DEVELOPMENT MANAGEMENT COMMITTEE - Wednesday 4 June 2014

Item 6 (Pages 13 – 25) – CB/14/01271/FULL – 126A High Street, Clophill.

Re: CB/14/01271/FULL Demolition of bungalow and erection of 4 bedroom detached dwelling at 126A High St, Clophill

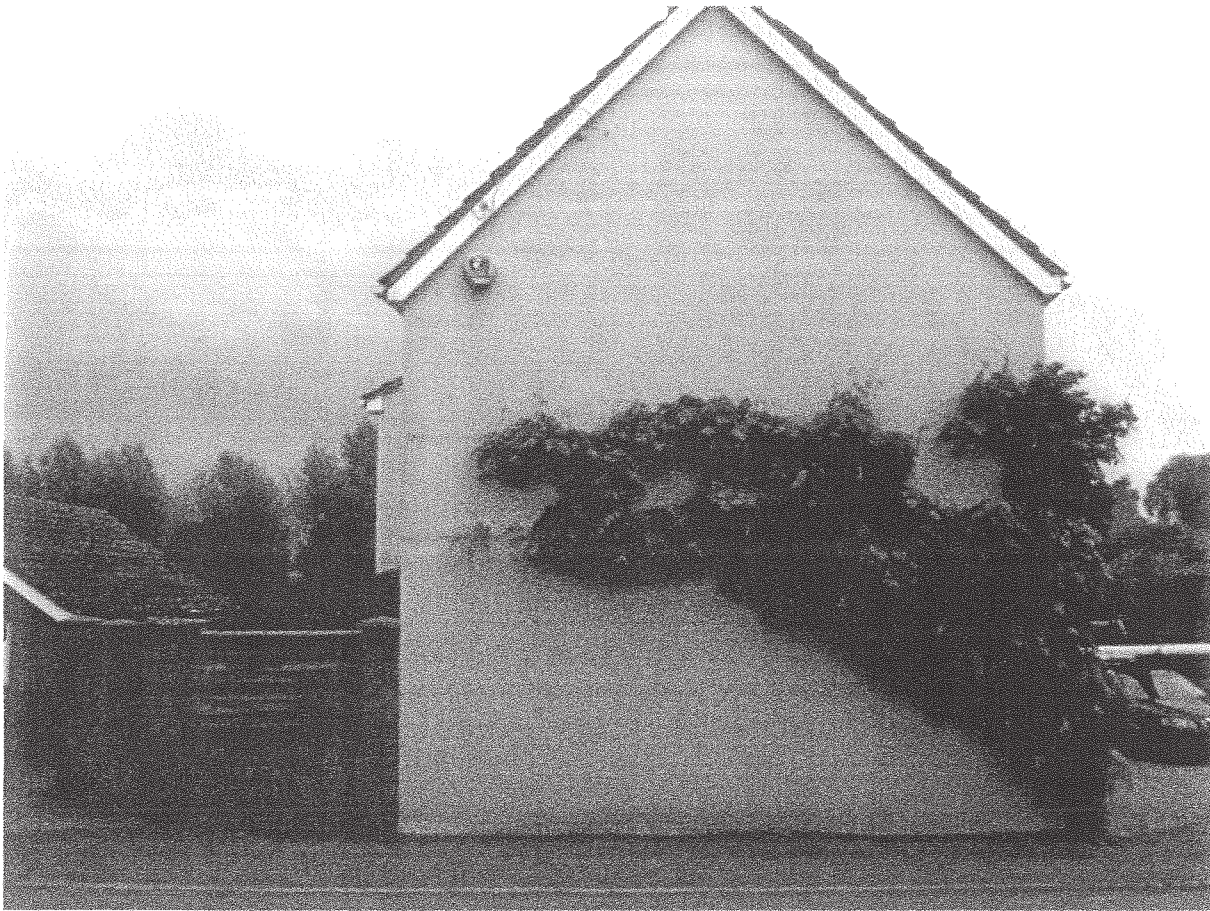
Paragraph 3 – this suggests that the 9.7m wide house will have 1.1m and 1.2m either side of it, making a total width of 12m. Given that the plot width on the front line is only 11.477m wide as measured with a laser, this maths does not add up. These kinds of discrepancies are unacceptable, because of the consequence on our amenity. We also pointed

Also in paragraph 3, I wish to dispute the 3.5m mentioned between our utility and kitchen windows and the proposed wall that faces it, which incorporates their kitchen window and kitchen door, as it is closer to 3m when you take into account the above paragraph and the fact that our breakfast room is still not shown on the site plan with which you have been provided. This means our home is 800mm closer to the boundary. Our breakfast room is 1m from the boundary fence, and NOT 1.9m. It is important that the dimensions are correct, due to the assessment that then needs to be undertaken.

It is not disputed that the 'maximum' depth of the house is 14 metres (approx.) The full width of the site at the roadside frontage is 12.5 metres (approx). The plot varies in width from front to rear and the dimensions given in the officers report in respect of the gaps on either side of the house up to its shared boundaries with neighbouring properties are considered to be accurate.

The dimensions in the officer's report regarding the distance between the breakfast kitchen area and the west facing walls of the proposed house are accurate as the breakfast area/kitchen is shown correctly in the submitted plans. As stated in the officers report the proposed house is to be sited between 3.5metres (approx) and 4.4 metres (approx) from the east facing walls of the house at number 126 High Street. Also, the nearest part of number 126 High Street is 1.0 m (approx) from the shared boundary with the application site as stated in the officer's report
